ROAD SAFETY ENGINEERING

SAFETY AUDIT REPORT

Project Name: Kings Parade, Cambridge – HVM

Audit Stage: Combined Stage 1 & 2

**SA 2162 – Kings Parade, Cambridge – HVM – Combined Stage 1&2 RSA
Problem Location Plan (NTS)**

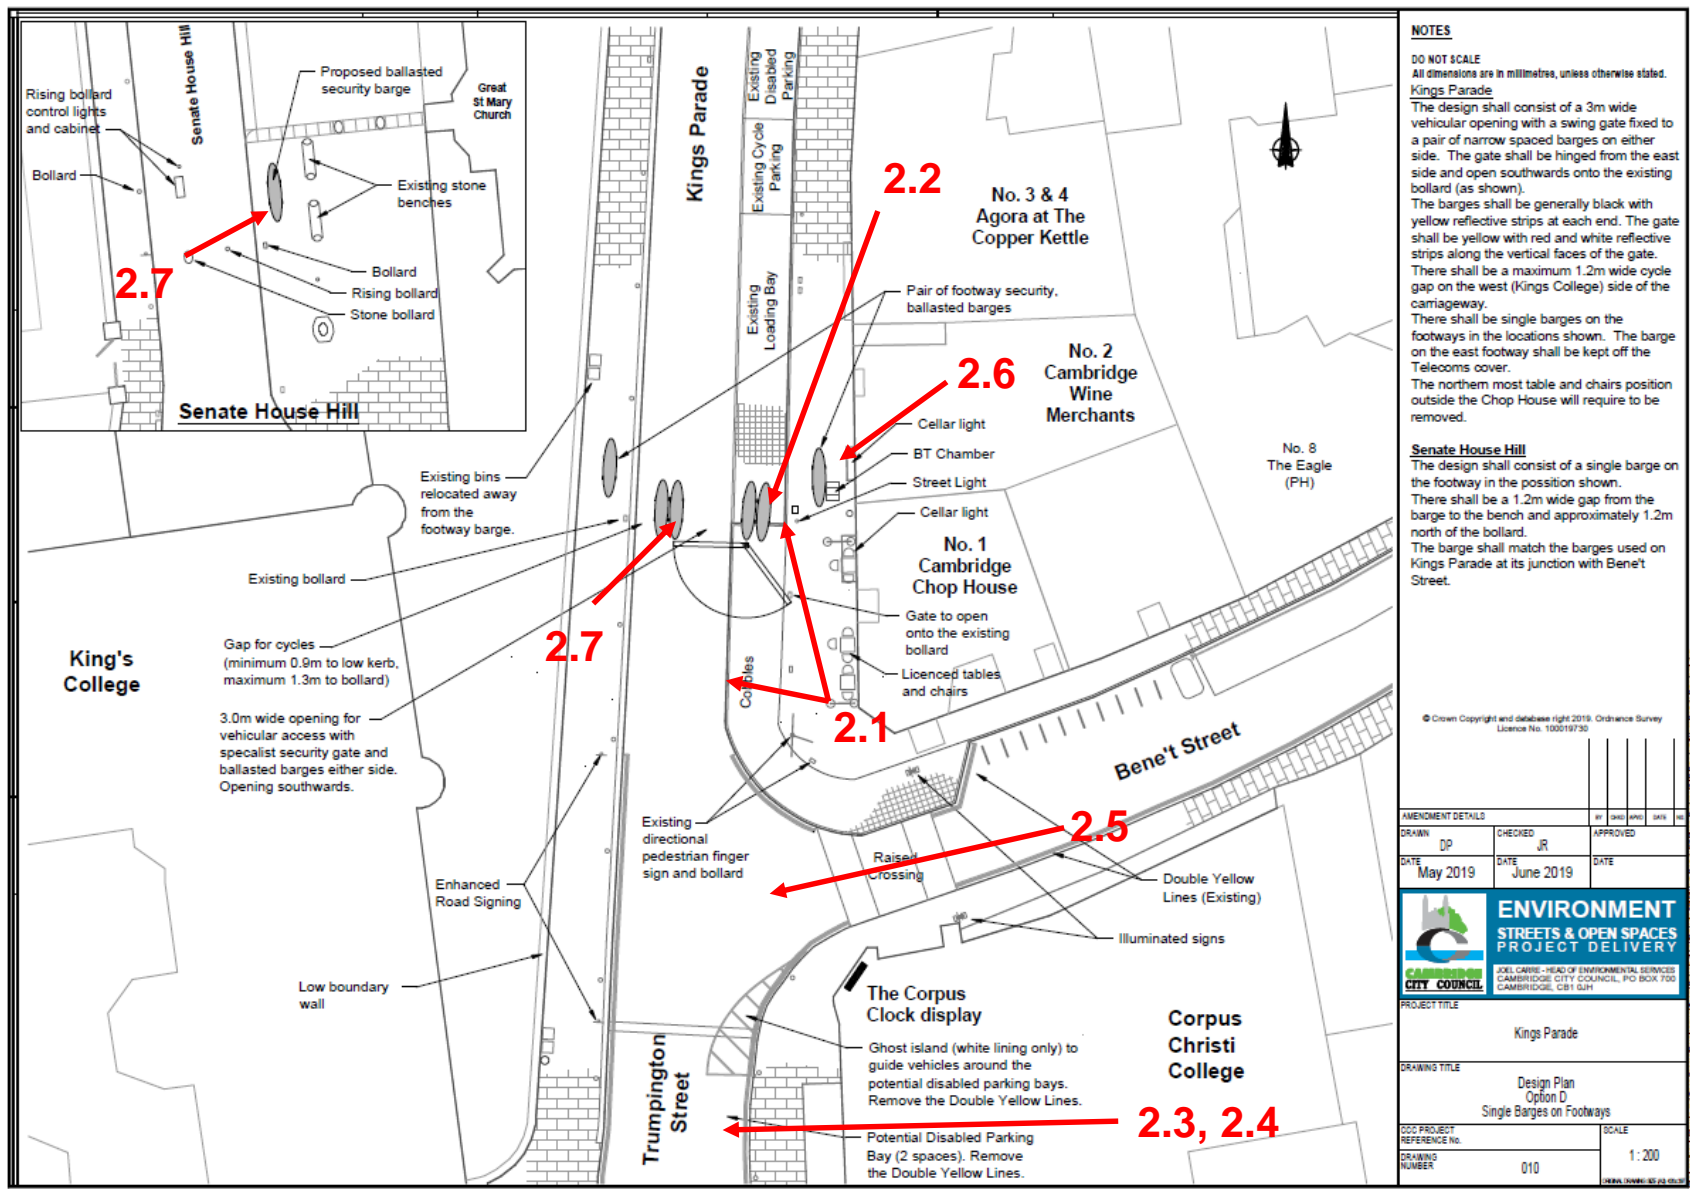
2.1 Problem

Location: King's Parade – southbound approach to the proposed HVM installation.

Summary: Increased risk of southbound cyclists losing control traversing granite setts and kerb upstands when bypassing the HVM installation.

The position of the HVM installation means that, when the gate is closed, southbound cyclists will be required to traverse the raised buildout located to the north of Bene't Street (east side of Kings Parade). The surface of the buildout is formed from granite setts and is bounded by a 40-50mm upstand where it bounds the carriageway. Cyclists traversing this feature are likely to be at increased risk of injury as a result of falling from their cycle.

2.2 Problem

Location: Kings Parade – southbound approach to the proposed HVM installation.

Summary: Increased risk of cyclists riding on footways and colliding with pedestrians or other cyclists due to the obstruction caused by the HVM installation.

High two-way flow of cyclists was observed on Kings Parade. When the HVM gate is closed, southbound cyclists will be forced over granite setts (see problem 2.1) and through the narrow gap on the eastern side of the gate (estimated to be less than 1m wide, significantly less than the dynamic envelope of a cyclist). The narrow width means cyclists may choose to ride on the footway, increasing the risk of collisions between cyclists and pedestrians, or choose to cycle through the wider gap on the

western side of the carriageway, resulting in the increased risk of head-on collisions with northbound cyclists.

2.3 Problem

- Location:** Trumpington Street south of its junction with Bene't Street
- Summary:** Large/long vehicles turning left out of Bene't Street are likely to collide with vehicles parked in the proposed disabled bay.

The proposed disabled bay to the south of Bene't Street may obstruct vehicle movements involving large/long vehicles turning out of the junction, resulting in the increased risk of turning vehicles colliding with vehicles parked in the disabled bay.

2.4 Problem

- Location:** Trumpington Street south of its junction with Bene't Street
- Summary:** Vehicles parked in the proposed disabled bay are likely to obstruct road users view to vehicles (including cyclists) when exiting Bene't Street.

Vehicles parked in the proposed disabled bay to the south of Bene't Street are likely to obstruct road users visibility to vehicles on Trumpington Street/Kings Parade, increasing the risk of failure to give way collisions involving road users exiting Bene't Street (with cyclists being most at risk).

2.5 Problem

Location: Kings Parade at its junction with Bene't Street.

Summary: Increased risk of collisions involving road users reversing into the path of vehicles exiting Bene't Street as well as NMUs crossing at the junction.

Kings Parade is only accessible from the south. Currently there is a generously sized turning head at the northern end of Kings Parade. This allows road users (with access rights) to turnaround and head back south in order to exit via the Trumpington Street/Silver Street junction. The turning head will not be accessible when the HVM gate is closed. This means road users are most likely to use the Bene't Street junction in order to turn around. This could result in the increased risk of collisions involving road users reversing into the path of vehicles exiting Bene't Street as well as NMUs crossing at the junction.

2.6 Problem

Location: Eastern side of Kings Parade at the proposed HVM installation

Summary: Increased risk of collisions between pedestrians and cyclists due to a combination the HVM measures and dining furniture causing an obstruction.

Tables and chairs were observed outside the Cambridge Wine Merchants (No. 2 Kings Parade). If these are still present when the proposed HVM installation is in place they will cause a significant obstruction within the eastern footway, essentially funnelling pedestrians and cyclists through the narrow gap between the gate and barge located on the footway. This

could result in the increased risk of collisions between pedestrians and cyclists.

2.7 Problem

Location: King's Parade and Senate House Hill – at the location of the proposed HVM installations.

Summary: Increased risk of pedestrians and cyclists colliding with the HVM installation during the hours of darkness.

The Audit Team acknowledge that the proposed HVM installations are to have reflective strips applied. However, full detail of the size and location of the reflective strips have not been provided. If the proposed installations are not conspicuously marked there may be an increased risk pedestrians and cyclists colliding with the HVM installations (both the gate and ballasted barges) during the hours of darkness, resulting in the potential for injury.

Recommendation

It is recommended that a suitable surface is provided along the route cyclists are expected to take and kerb upstands dropped flush to reduce the risk of cyclists falling from their cycle.

Recommendation

It is recommended that the width of the gap on the eastern side of Kings Parade should be increased, with the width provided being appropriate for the speed and volume of cyclists expected.

Recommendation

It is recommended that swept path analysis is undertaken for all design vehicles and the disabled bays removed or relocated as necessary if large vehicles are likely to overrun the bays.

Recommendation

It is recommended that the disabled bays removed or relocated as outside the junction visibility splay.

Recommendation

It is recommended that appropriate turning provision is made on the southern side of the HVM installation to reduce the likelihood of road users using Bene't Street as a turning head or make Trumpington Street one-way in the southbound direction between Bene't Street and Silver Street to negate the requirement for a turning head.

Recommendation

It is recommended that the area in the immediate vicinity of HVM installation is kept clear of table and chairs.

Recommendation

It is recommended that both the gate and ballasted barges are conspicuously marked with reflective bands.
